Access Compliance Report Public Rights-of-Way (Curb Ramps)

Main Street: SHAKESPEARE_DR Cross Street: HARRISBURG_RD Location: NE

ADA ID: RPAT211202093131 Ramp Type: Type 1 - Perpendicular Diagonal Initial Pass/Fail: Pass Overall Compliance: No Severity Score: 22

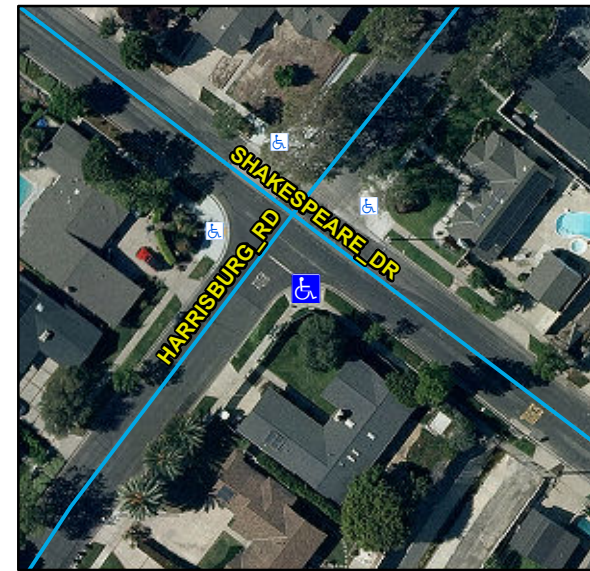
Remove & Replace Curb Ramp With Two New Directional Ramps or Equivalent. Remove & Replace Gutter.

R304.2.2, R204.3, R304.2.1, R304.5.3, R305, R304.5.4, STD 1115
